TATA CONSULTING ENGINEERS LIMITED
VENDOR DOCUMENT REVIEW STATUS

PROJECT: LSTK JOB FOR ISBL WORK OF 220kV GRID POWER IMPORT AT PANIPAT REFINERY
LOA NO. RPRC182491/26286965 DTD.24.01.2020

TITLE: 220/33KV SWITCHYARD–SINGLE LINE DIAGRAM

DRAWING / DOCUMENT TITLE: GIS cum Control Room Building- Conceptual Layout
DOCUMENT NUMBER: TB-411-510-020
REVISION NO: 03

DRAWING/ DOCUMENT NO. TB-411-316-020 REV. 04

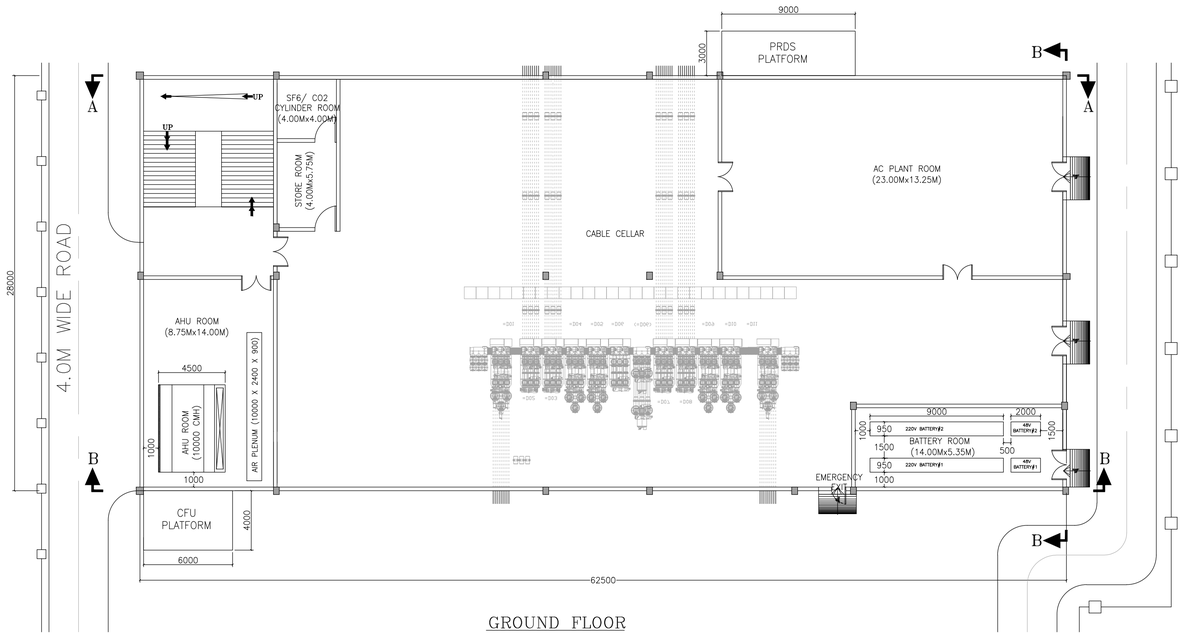
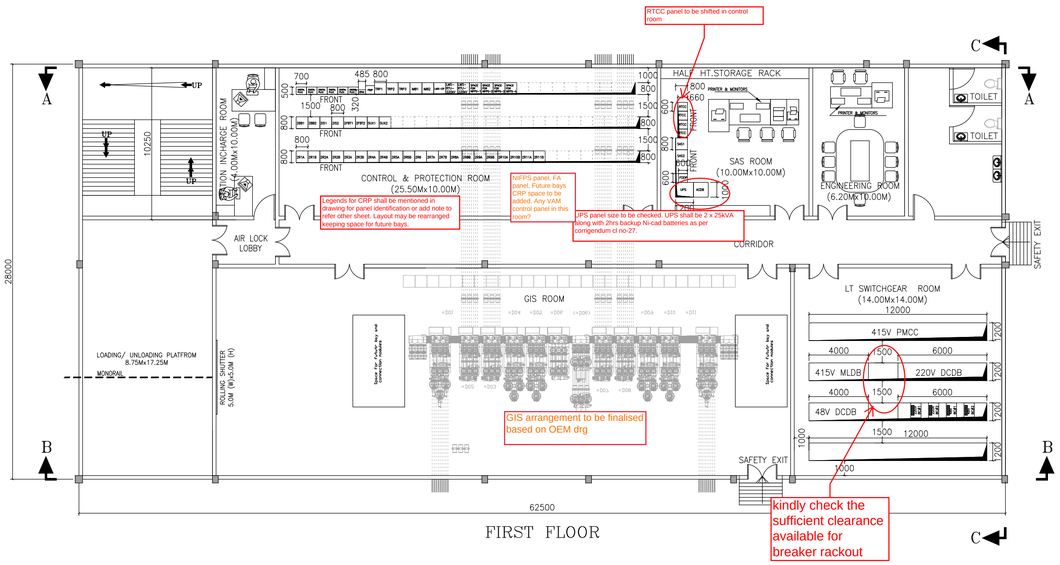
Approved for conceptual layout. Same shall be further revised based on actual OEM GA etc and Civil and ARch drgs for rooms. BHEL to comply with comments given earlier in detail Engineering.

A.	CONSULTANT (dtd. 16.03.2020)												
	Electrical												
1	Plan	GIS LCC panel shall be shown as one per bay with dimension of 1000-1200mm as per vendor input.		Noted. Please note that such details are tentative and shall be revised, if required in line with OEM drawings/ design documents.				Ok noted	Ok noted				
2	Plan	Wherever column comes SF6 Duct or Cable Opening shall be rearranged to avoid fouling.		Noted. Please note that such details are tentative. Civil and structure design documents shall be submitted subsequently after approval of this drawing/ document.				Ok noted	Ok noted				
3	Plan	GIS bays shall be placed in between beams and not on beams.		Noted. Please note that such details are tentative. Civil and structure design documents shall be submitted subsequently after approval of this drawing/ document.				Ok noted	Ok noted				
4	Plan	ACDB & DCDB shall be aligned as per as per cable trench route proposed		Noted. Please note that such details are tentative and shall be revised, if required in line with OEM drawings/ design documents.				Ok noted	Ok noted

5	Plan	No of staircase to be check considering building size as per relevant building standards.		Noted. Please note that such details are tentative. Civil and structure design documents shall be submitted subsequently after approval of this drawing/ document.				Ok noted	Ok noted				
6	Plan	More sections to be provided showing GIS room with EOT crane arrangement, loading platform etc.		Noted. Please note that such details are tentative. Civil and structure design documents shall be submitted subsequently after approval of this drawing/ document.				Ok noted	Ok noted				
7	Plan	No of exit to be check considering building size as per relavant building standards.		Noted and complied.				Ok noted	Ok noted				
8	Plan	All inner dimension of rooms shall be provided. All dimension between panel to panel, panel to wall etc to be shown.		Noted. Please note that such details are tentative. Civil and structure design documents shall be submitted subsequently after approval of this drawing/ document.				Ok noted	Ok noted

9	Plan	NIFPS panel shall be shown		Noted. Please note that such details are tentative and shall be revised, if required in line with OEM drawings/ design documents.				Ok noted	Ok noted				
10	Plan	TR-3 (trench type) name mentioned in 1st floor GIS room to be removed		Noted and revised.				Ok noted	Ok noted				
11	Plan	Exhaust fan arrangement for Toilet & Pantry to be shown		Noted. Please note that such details are tentative and shall be revised, if required in line with OEM drawings/ design documents.				Ok noted	Ok noted				
12	Section A-A	Cable termination arrangement in SAS/ Control room to be shown. Whether False floor to be provided or else cable entry for panel will be form top.		Noted. Please note that such details are tentative and shall be revised, if required in line with OEM drawings/ design documents.				Ok noted	Ok noted				
13	Plan	In ground floor GIS & LCC panel can be shown dotted as it is placed on 1st floor. Bus duct to be shown in ground floor		Noted. Please note that such details are tentative and shall be revised, if required in line with OEM drawings/ design documents.				Ok noted	Ok noted

14	Plan	Bay name shall be mention for each GIS module		Noted. Please note that such details are tentative and shall be revised, if required in line with OEM drawings/ design documents.				Ok noted	Ok noted				
15	Plan	No. of CRP panels shown is more compared with 220kV feeders. Panel identification shall be done. CRP panel alignment to be checked.		Noted. Please note that such details are tentative and shall be revised, if required in line with OEM drawings/ design documents.				Ok noted	Ok noted				
16	Plan	Eye wash to be provided in battery room		Noted. Please note that such details are tentative. Civil and structure design documents shall be submitted subsequently after approval of this drawing/ document.	Requirement is for Eye wash.		Noted.	Ok noted	Ok noted				
17	Plan	UPS not shown in drawing		Noted. Please note that such details are tentative and shall be revised, if required in line with OEM drawings/ design documents.				Ok noted	Ok noted

18	Plan	TR-2 cable trench (3Mtr wide) shown for battery room cables is too large for cables coming from battery room to DC system.		Noted and Revised.				Ok noted	Ok noted				
19	Plan	Door to be provided in 1st floor staircase for entering into loading/unloading platform		In first floor, staircase shall not be covered and it shall be open. Civil and structure design documents shall be submitted subsequently after approval of this drawing/ document.				Ok noted	Ok noted				
20	General	Room with false celing & false floor shall be shown in section drawing		Noted. Please note that such details are tentative. Civil and structure design documents shall be submitted subsequently after approval of this drawing/ document.				Ok noted	Ok noted				
21	Plan	Steps & door shall be shown at ground floor stair case entry point		In ground floor, staircase shall not be covered and it shall be open. Civil and structure design documents shall be submitted subsequently after approval of this drawing/ document.				Ok noted	Ok noted

22	GIS room	GIS room height shown as 11mtrs in 220/33kV layout Plan & Section. Kindly confirm		Noted and revised.				Ok noted	Ok noted

25	Plan	Roof layout indicating busduct shall be provided		Please note that these details are tentative and indicated and shall be revised based on OEM drawings, which shall be submitted separately and such requirements shall be taken care during that.				Ok noted	Ok noted				
26	Section A-A	Raised floor / power cable entry, HVAC cable entry to be shown.		Please note that these details are tentative and indicated and shall be revised based on OEM drawings, which shall be submitted separately and such requirements shall be taken care during that.				Ok noted	Ok noted				
27		EHV cable trench is passing below the HVAC room. Kindly reroute the EHV cable to avoid fouling.		In ground floor, staircase shall not be covered and it shall be open. Civil/ Mechanical drawing shall be submitted subsequently after approval of this drawing/ document.				Ok noted	Ok noted				
28		Service shaft / fire hose shall be shown in drawing		In ground floor, staircase shall not be covered and it shall be open. Civil/ Mechanical drawing shall be submitted subsequently after approval of this drawing/ document.				Ok noted	Ok noted

56	Section A-A				Satircase block should have opening/access to roof florr.		Such detaills shall be provided and incorporated in architectural and civil drawings, which shall be submitted separately.	Ok noted	Ok noted				
57	Section A-A				Requirement of false ceiling and false flooring to be taken care during further detailing		Such details shall be provided in AC & Ventilation drawings, which shall be submitted separately.	Ok noted	Ok noted				
58	PR Extension Room, Sheet-2				1) Room to be provided with proper access. Entry/Exit etc 2) Room Height should match with existing control room.		Noted and complied.	Ok noted	Ok noted				
59	General				No of panels can be determined based on experience of past project also.		These details are under preparation and exact details for the requirement shall be intimated and shall be made the part of the drawing.	Ok noted	Ok noted				
60	General				Some replies are not in line with comments given.		It may please be noted that the basis purpose of this drawing is locating equipmet and layouting of the rrom with electrical clearances. General requirements such as door, window, ventilators and paraphet etc. shall be covered in architectural and civil drawing, which shall be submitted separately and subsequently.	Ok noted	Ok noted

VIEW A–A
(TYPICAL DETAILS)

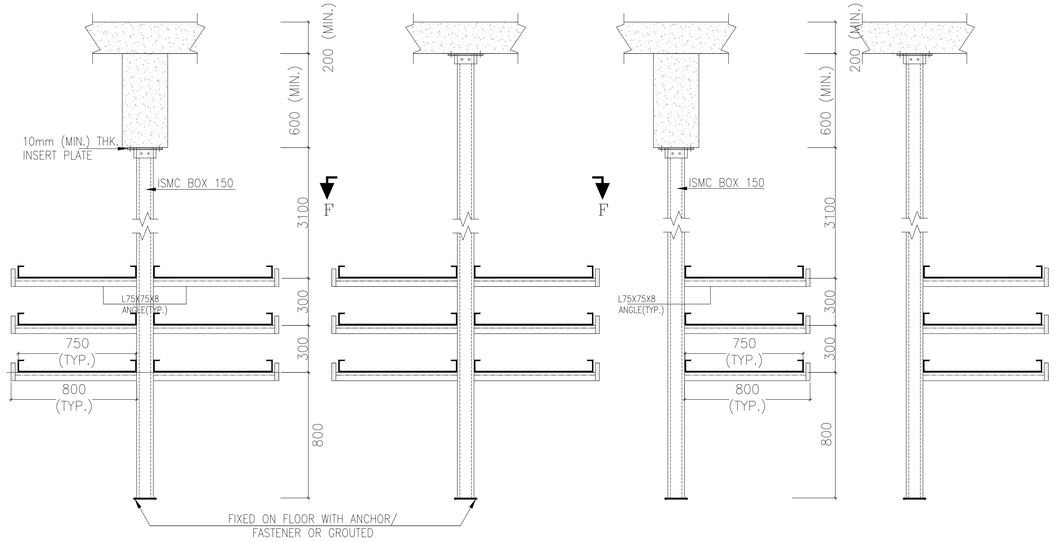
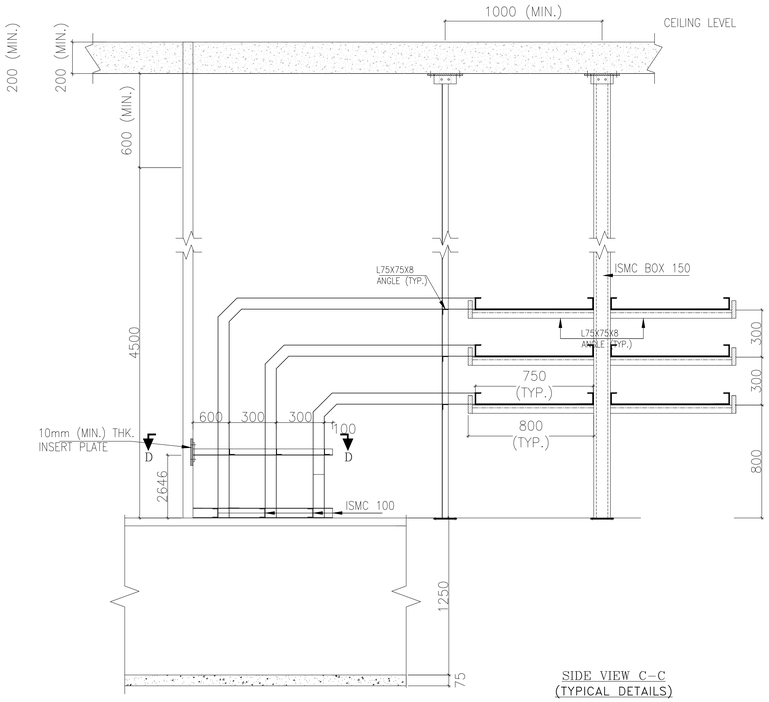
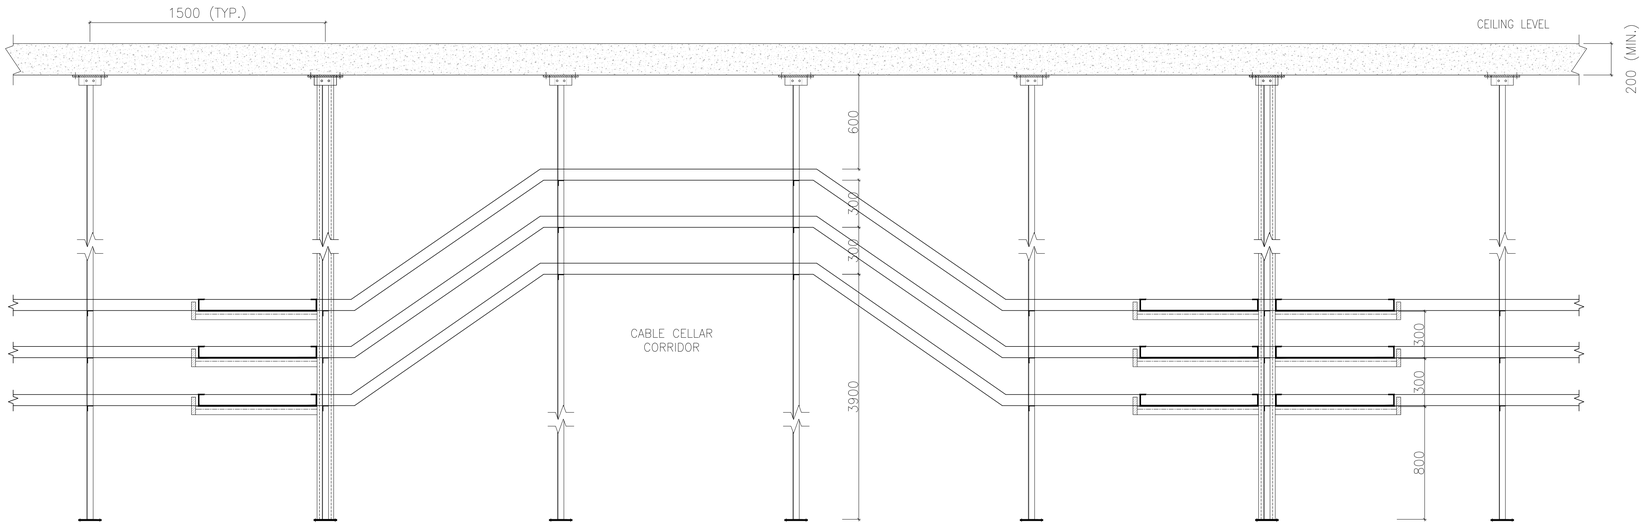
24			The hanger support shall not be followed. Please revise thre drawing and indicate the provision with support from the floor of the cellar. Necessary provision to be kept for man movement through and through of the cable cellar. The photograph of the existing system of the cellar shall provided seperately for bettery understanding of the system	Noted and complied.	Ok noted	Noted										
25					For LT power and control cables, GIS perforated cable tray to be used.		In line with technical specification, only ladder trays are envisaged.	As per specification cl no-5.7.1 "cable trays may be either of perforated sheet type or of ladder type". So Perforated type cable tray can be used for control cables & Ladder type for Power cables, however ladder tray also acceptable.		Noted for ladder type trays.						
26					First floor equipment to be shown in light to check and confirm location of trays and to avoid conflict		Noted and complied.	Noted
